ANN ARBOR HISTORIC DISTRICT COMMISSION

Staff Report

ADDRESS: 218 Eighth Street, Application Number HDC13-099

APPLICATION: The applicant seeks HDC approval to remove the existing concrete porch and construct a new wooden porch.

Figure 4. 218 8th Concrete Porch Front View

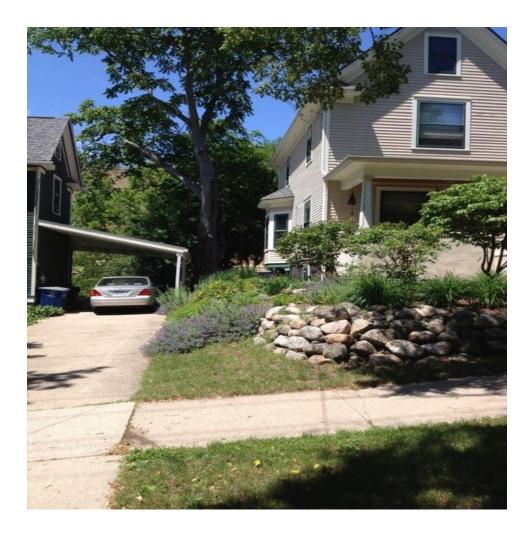
1. The existing front porch is concrete, with solid walls, wooden steps, and Craftsman-style columns. The applicant seeks approval to demolish the concrete portion of the porch and

remove the existing columns. The roof will remain. The applicant states that the concrete portions of the porch are deteriorating and in need of replacement. The concrete and the Craftsman columns are clues that this porch is not original, and a letter from a neighbor who recalls an earlier wood porch being removed serves as further evidence.

Figure 9. 218 Eighth Street Elevations

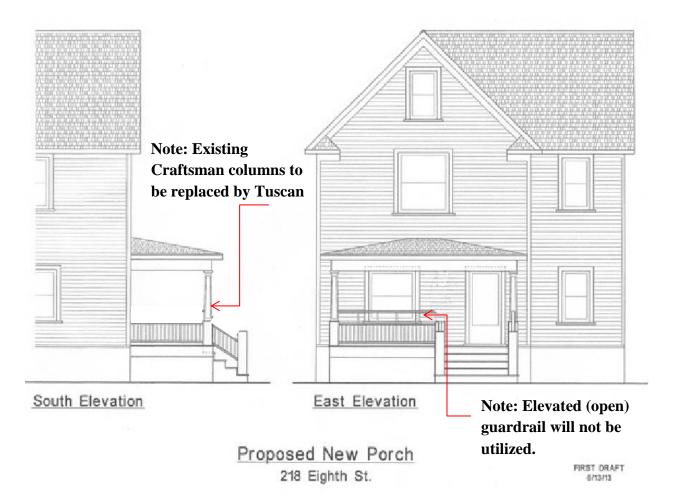
- 2. The proposed front porch is constructed of wood. The proposed decking is tongue and groove 1" by 4" IPE. The skirting is 1" by 6" western red cedar and will be infilled with custom-made western red cedar lattice. The lattice will be squares, which is more appropriate than lattice on the diagonal. The railing will also consist of western red cedar, with beveled top and bottom rails and 1.5" square balusters.

- 3. Two proposed tall columns, one at either end of the porch, will be Turncraft Poly-Classic columns with a simple Tuscan style. These columns consist of a fiberglass-reinforced polymer. Two short columns of the same style and construction will be located at the foot of the stairs.

- 4. The new work is distinguished by the simple, plain design. The tongue and groove IPE decking and fiberglass columns are acceptable materials since they are not replacing existing historic materials and the new porch is not replicating a historic design. Staff feels that overall design and massing are compatible with the historic house and neighborhood, and meet the Secretary of the Interior's Standards and the Ann Arbor Historic District Design Guidelines.
